Response to Submissions

Sydney Olympic Park Master Plan 2030 (Interim Metro Review)

April 2022

Sydney Olympic Park Authority

Figure 2: Master Plan 2030 views from Site 50 to the east

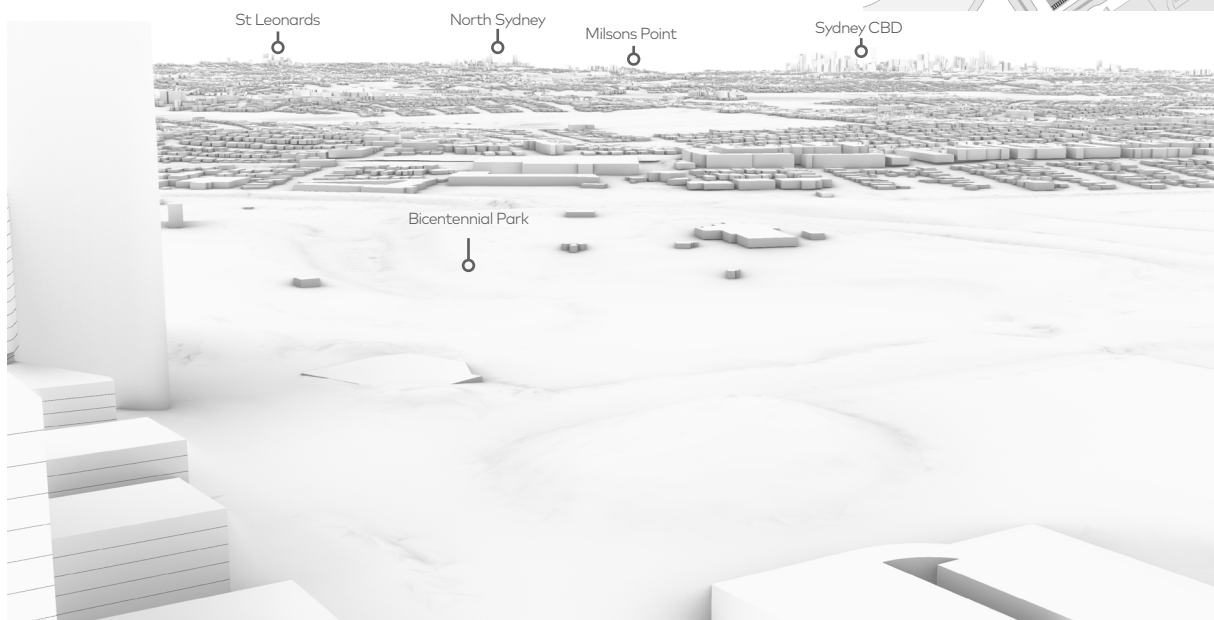
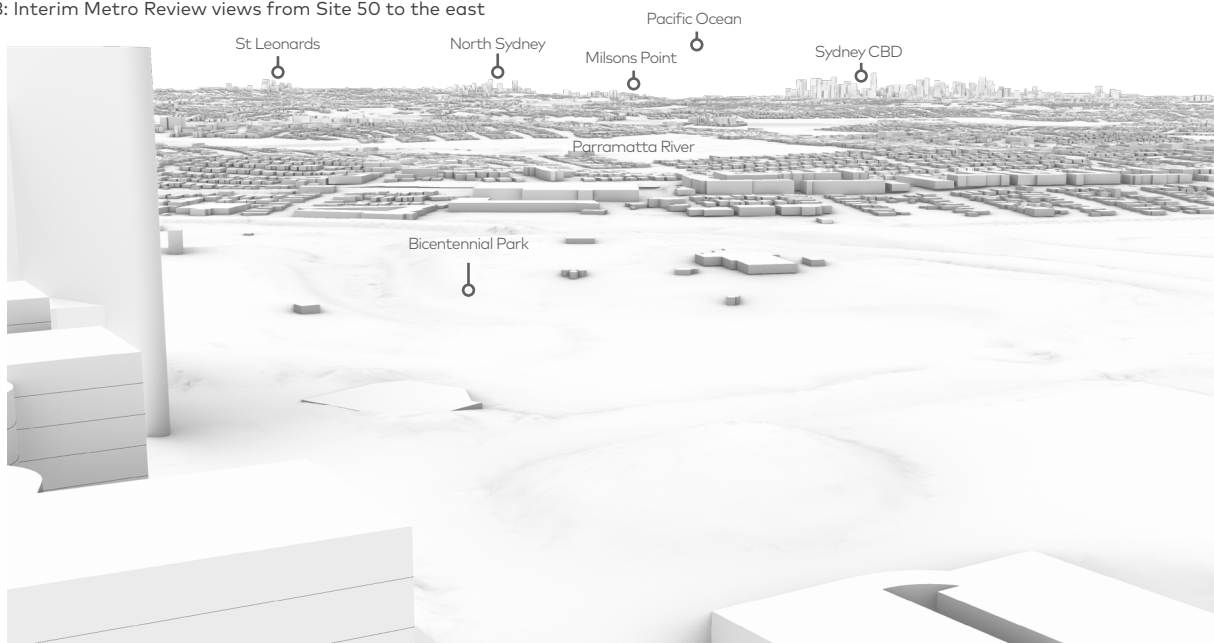
In their submission to the exhibition of the Interim Metro Review Dunnet Properties Pty Ltd raised concerns regarding loss of views compared to the potential development outcomes within the Master Plan 2030. Additional view analysis to significant landmark structures and views was requested and is included in the following pages.

Figures 2, 4, 6 and 8 presents a potential built form that is permissible under the controls of the currently approved Master Plan 2030, which was developed prior to the announcement of Sydney Metro at Sydney Olympic Park. Of particular relevance to the view analysis, the maximum heights proposed under the Master Plan 2030 are 45 storey on Site 48, 8 storeys on Site 40 and 20 storeys on Site 47.

Figures 3, 5, 7 and 9 represents the potential built form permissible under the Interim Metro Review. This Master Plan amendment recognised the importance of Metro as a significant landmark in the Central Precinct skyline and the role it would play as the central heart of activation. For these

Figure 11: Master Plan 2030 controls vs Interim Metro Review - Winter Solstice (21st June) 9AM

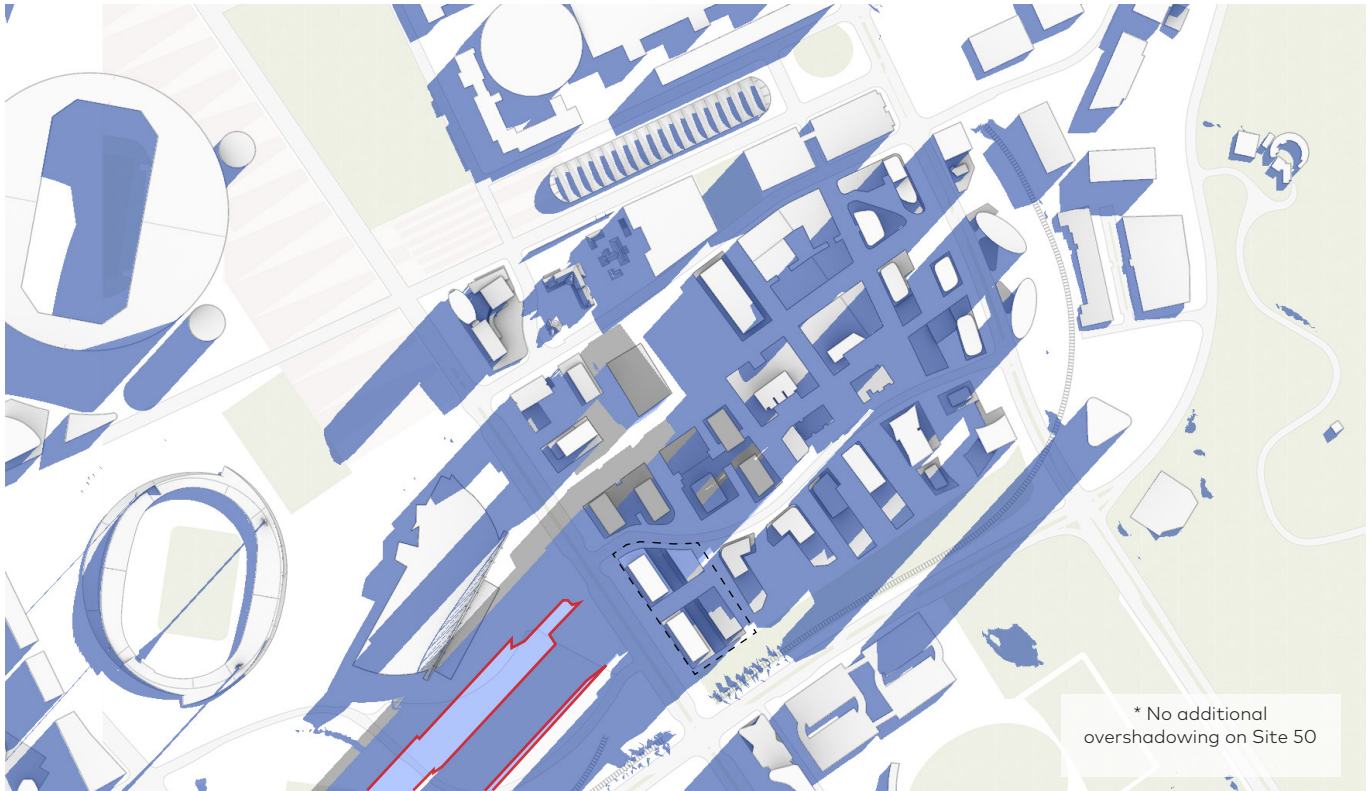
In their submission to the exhibition of the Interim Metro Review Dunnet Properties Pty Ltd raised concerns about additional overshadowing impacts compared to the potential development outcomes within the Master Plan 2030. The Interim Metro Review explores a potential revision to the Central Precinct that responds to the significant, catalytic opportunity afforded by Sydney Metro West and the enhanced levels of accessibility and amenity that it provides.

The diagrams identify shadows cast by the Master Plan 2030 that are not present in the Interim Metro Review in grey. That is, less of an overshadowing impact is caused by the Interim Metro Review.

The comparative analysis of the Master Plan 2030 and Interim Metro Review illustrates that during the winter solstice (Figures 11,12 and 13), there is some additional overshadowing which predominantly falls outside Central Precinct. While there are some additional narrow strips of shadow within the Central Precinct from the Interim Metro Review, these are considered likely to have a negligible effect on surrounding sites. With regards to Site 50, additional overshadowing resulting from the Interim Metro Review is very limited and considered to be negligible.

Figure 20: Site 50 existing orientation (South Perspective) with Interim Metro Review context

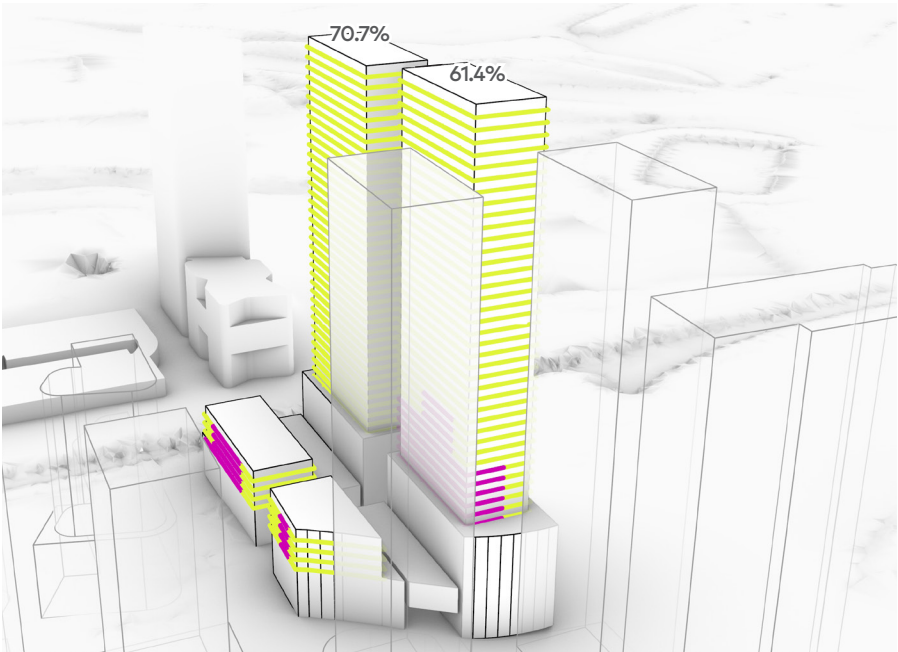
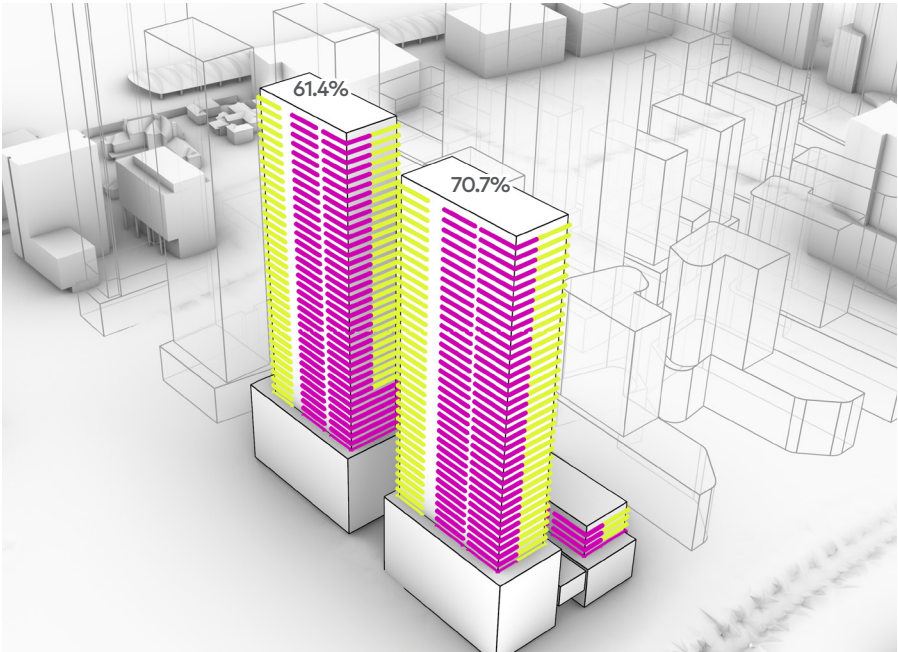
Dunnet Properties Pty Ltd (prepared by Higgins Planning)	
Inconsistent building heights and overshadowing and view loss	<p>Dunnet Properties notes the proposed changes to heights within this review deviates from previous height principles and raises concern with regard to potential overshadowing and view loss on their site located to the south.</p> <p>The introduction of a Metro station to Sydney Olympic Park affords a catalytic opportunity for Sydney Olympic Park and specifically the sites within the Central Precinct in terms of access and increased development potential. This Interim Metro Review precedes the comprehensive Master Plan 2050 review to align with Sydney Metro's construction timeframes.</p> <p>Regarding building heights and scales, only Site 47 will see increased height provisions (Table 3 in the Planning Report). Site 40 will see a height decrease. The other sites subject to this amendment are not proposed to have any increased height provisions.</p>

The Proof of Concept shown in the images to the right represents one of many options as to how the development potential of Site 50 may be realised and is limited to a single typical floorplan replicated across all levels of the towers.

Even without considering the site in detail (envelopes have been modelled not detailed building designs), one building exceeds the ADG requirements for solar access (70.7%). There is confidence that through architectural consideration of floor plans, apartment layouts and mix of typologies, that both towers on Site 50 can readily meet or exceed ADG requirements with regards to solar access. Moreover, both sites 48 and 50 are design excellence sites and each will need to respond to the precinct context, which would only improve amenity including solar access.
